Access Compliance Report
Public Rights-of-Way
(Pedestrian Signals)

Intersection ID: N/A	**Main Street:**	**Cross Street:** N/A	**Location:** N/A
ADA ID: 0449202D3099	**Signal Type:** One Push Button-Non APS	**Overall Compliance:** No	**Severity Score: BTN 1:** N/A **BTN 2:** N/A **No BTN:** N/A

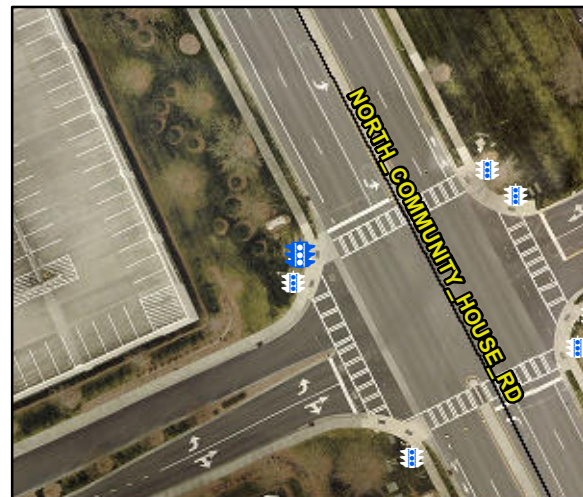
PROW/ADA: TMUTCD 4e.08, R404.2, R404.7.3, R406

Possible Solutions: Replace Signal Push Button With APS Button on New Post. Remove & Relocate Sign.
